SPARKS WITHINGTON CO.

MODEL 61, 62
Schematic, Voltage

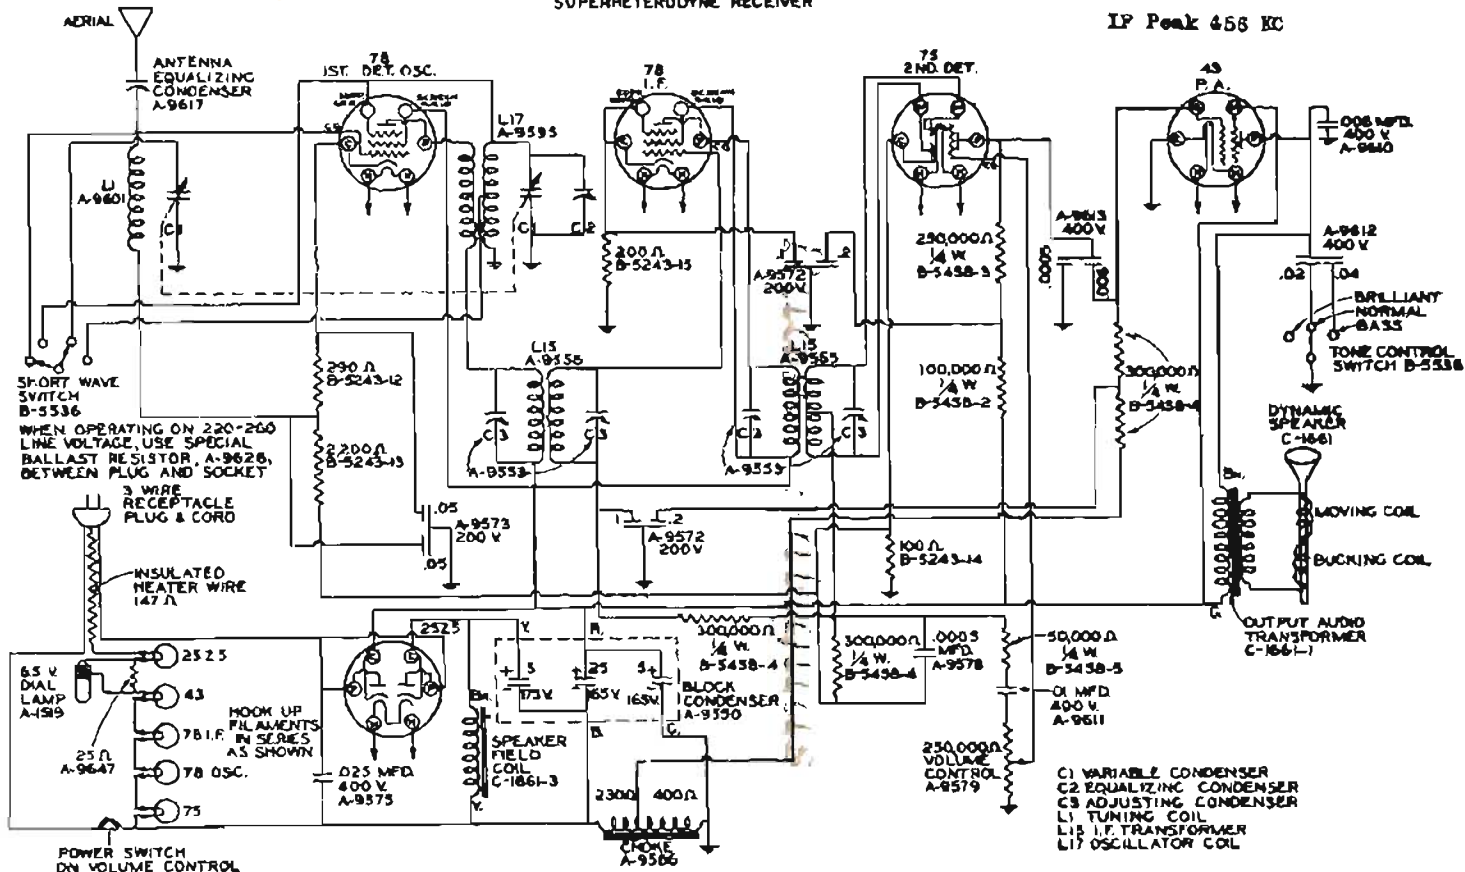
A 50-ohm, 2-watt resistor, Part No. B-6061-1, has been added in series with the plate lead of the 25Z5 that is drawn nearest the speaker field in the schematic diagram, shown on Sparton page 4-11 in Rider's Volume IV. This resistor protects the 25Z5 tube against voltage surges.

It is advisable to put this resistor in any Models 61 and 62 not so equipped that you may service.

Changes to be made in Silvertone Models 1720, etc.

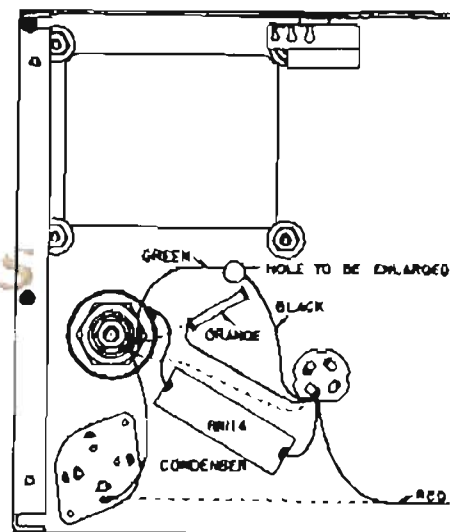
Any trouble due to hum in these models can be eliminated by performing the following operations, the purpose being to add an additional section of filtering to the power supply.

Enlarge the hole in the chassis near the power transformer to about 0.25 inch diameter, as indicated in the illustration.

Mount a Part No. R10793B choke on top of the power transformer in place of the original transformer cover. Be sure to mount the choke so that its leads can come down through the enlarged hole in the chassis. Also be sure to tighten the bolts well, in order

Make the wiring changes indicated in the illustration. The dotted lines represent the original wiring, which is to be changed and the solid lines show the new connections. Note that a new part, a 2-mf., 440-volt, dry electrolytic condenser, Part No. R11114, is added.
